**THE REGIONAL MUNICIPALITY OF YORK
ADDENDA # 4
T-19-16**

FOR: Construction of Paramedic Response Station No. 29 at 107 Glen Cameron Road in the City of Markham

ARCHITECTURAL ADDENDUM 02

York Region Paramedic Response Station #29
107 Glen Cameron Road, Markham

DATE: 2019/07/09
SCALE: As indicated DRAWN BY: SRL
DWG STATUS: TENDER
PROJECT NO: 1509
DRAWING NO: A4.1 REVISION: 12

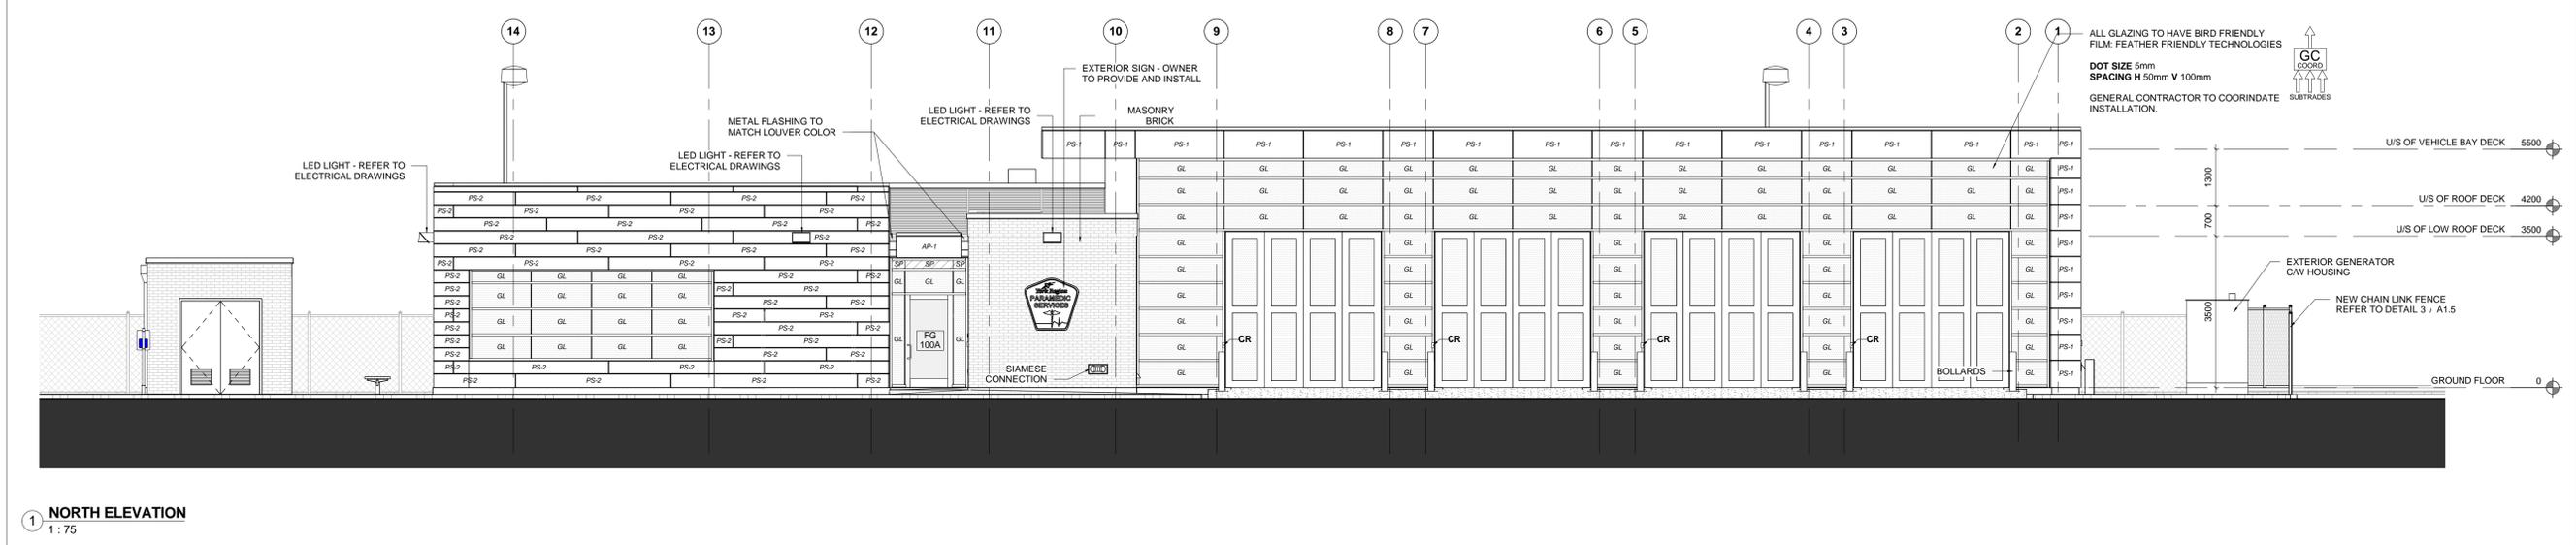
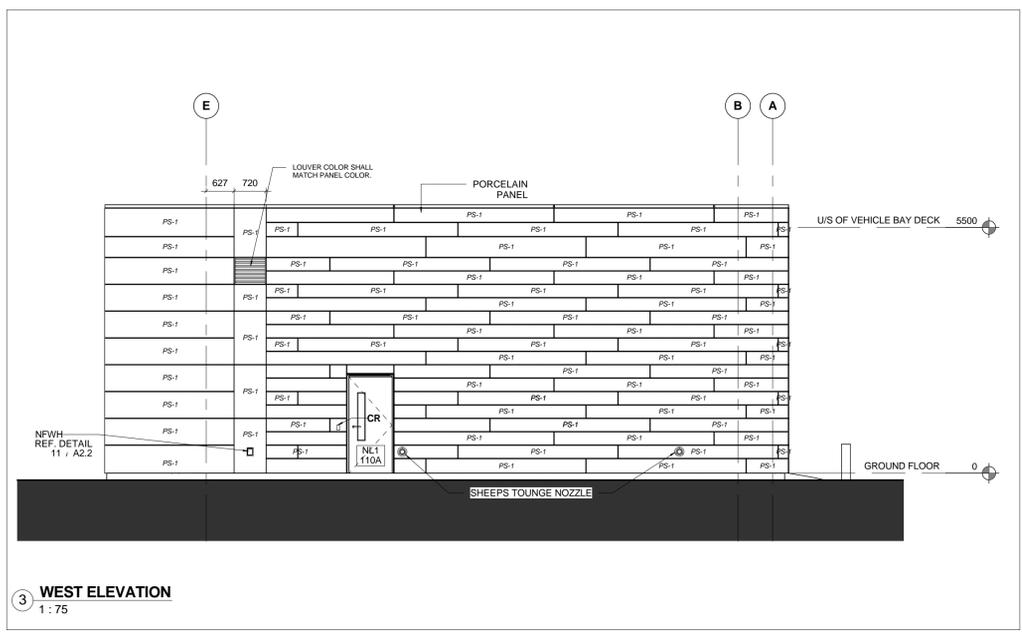
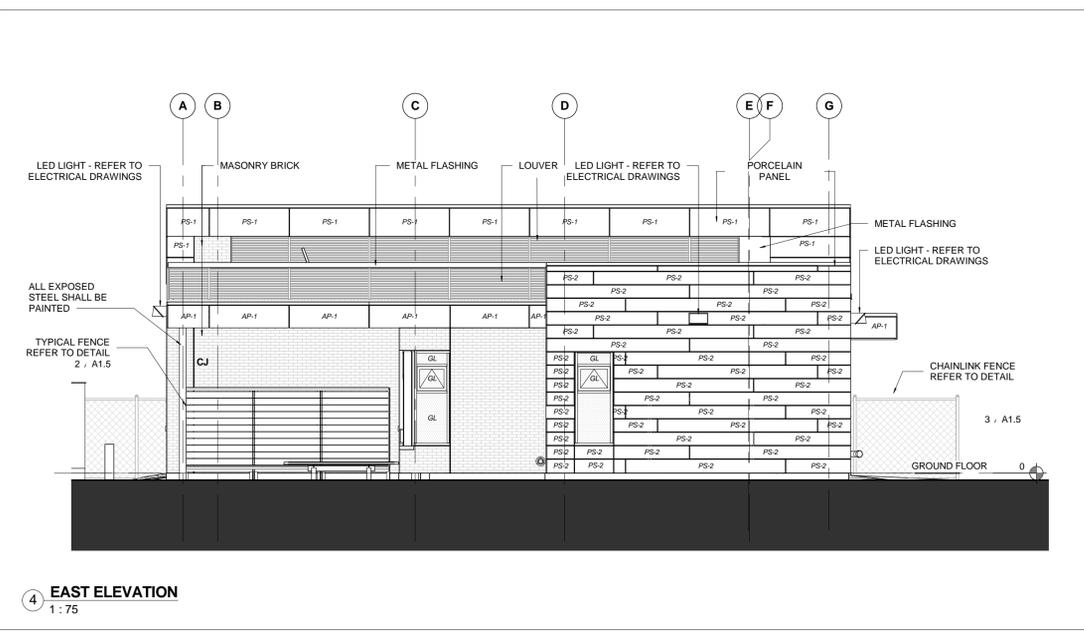
Q10 What are the required bricks? Architectural Drawing A4.1 indicates “Belden Brick – Gray Bricks 691-693” (no size indicated) but specifications indicate Modular-sized ‘Manganese Ironspot Velour’ by Endicott. Please clarify.

- .1 Revise Masonry Brick to note Manganese Ironspot Velour.
- .2 Revise Louvers finish from Charcoal Grey to "Black".

A Brick Masonry for the project shall be Modular-sized ‘Manganese Ironspot Velour’ by Endicott as specified.

DATE	2019/07/09
SCALE	As indicated
DRAWN BY	SRL
DWG STATUS	TENDER
PROJECT NO.	1509
DRAWING NO.	A4.2
REVISION	12

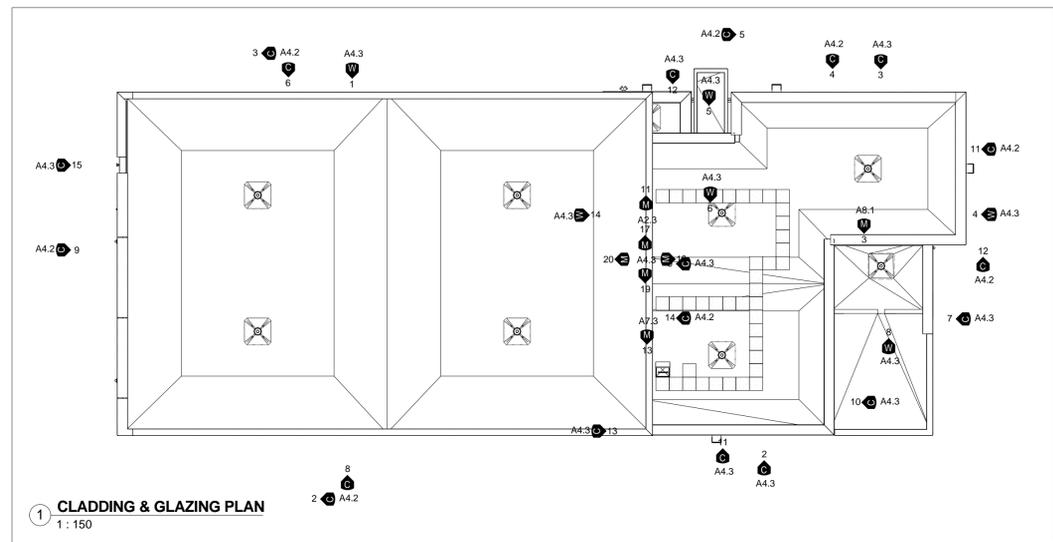
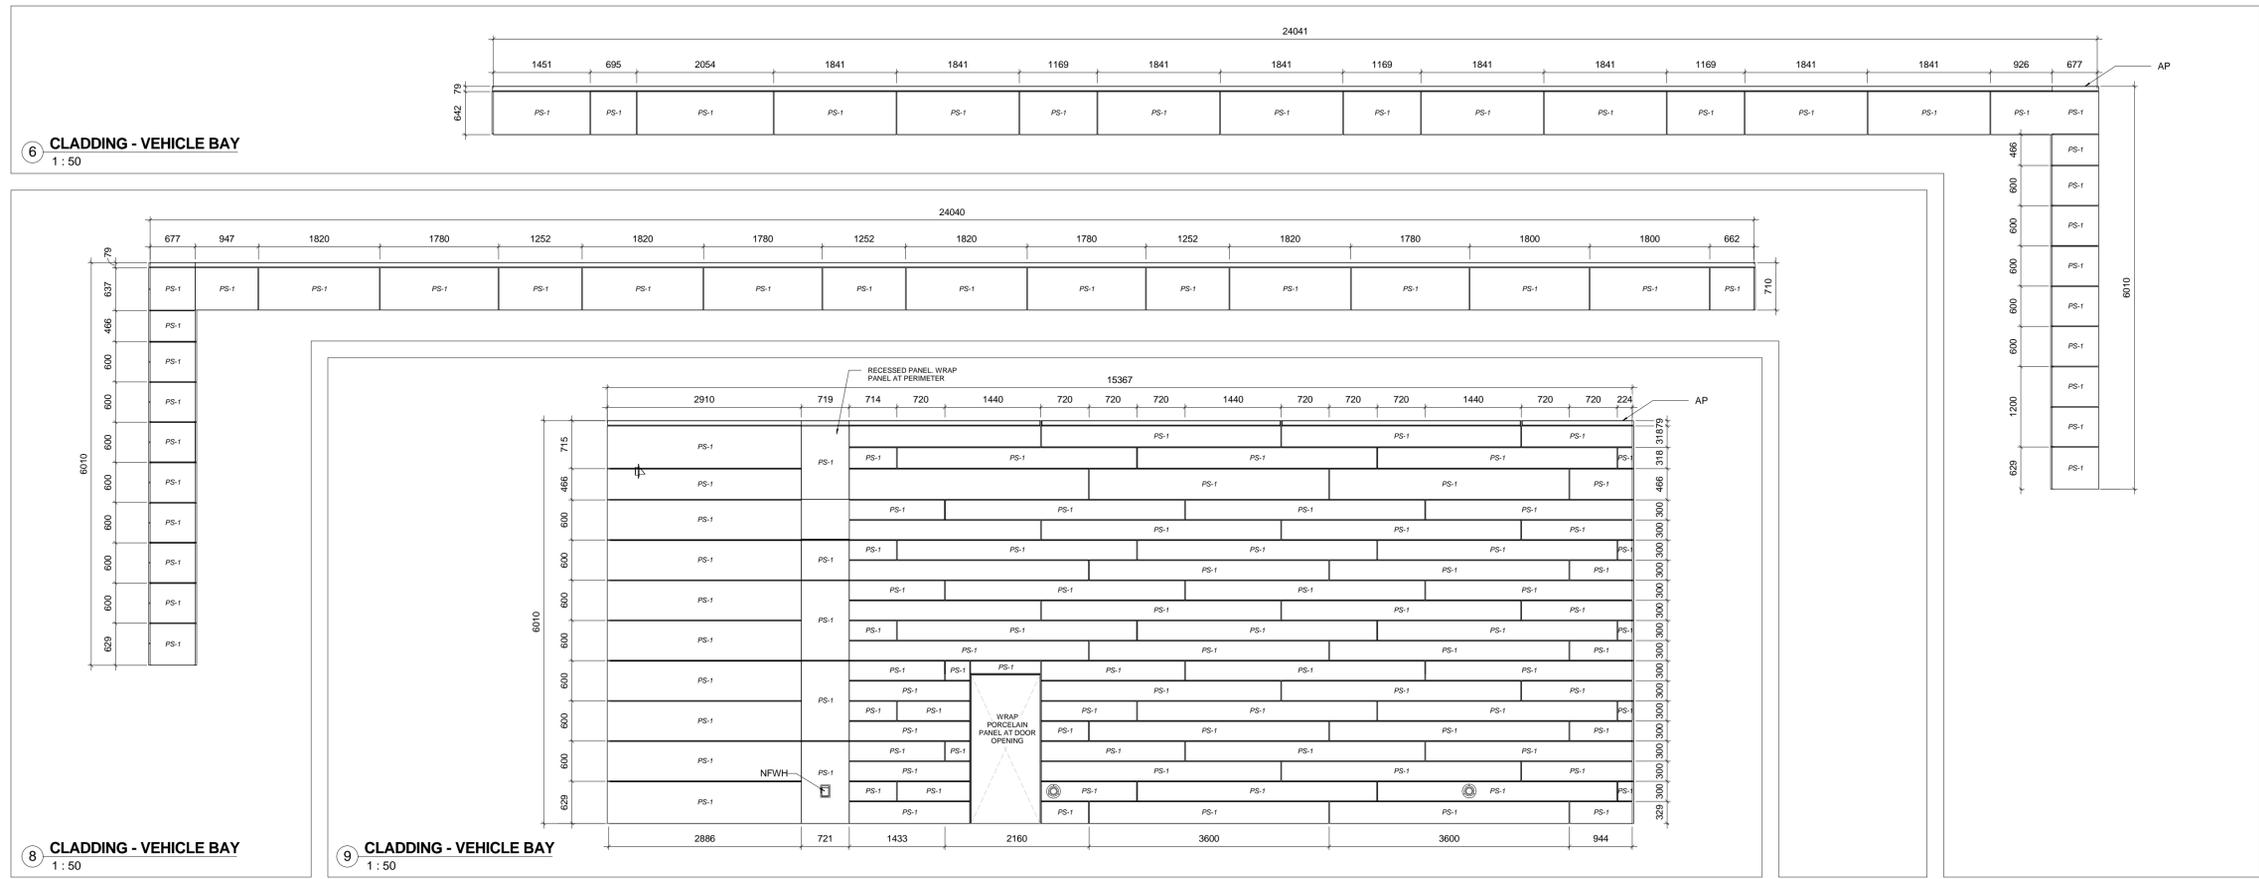
- .1 Revise Pre-Finished Metal Flashing F1 to Agway QC 28262 Black.
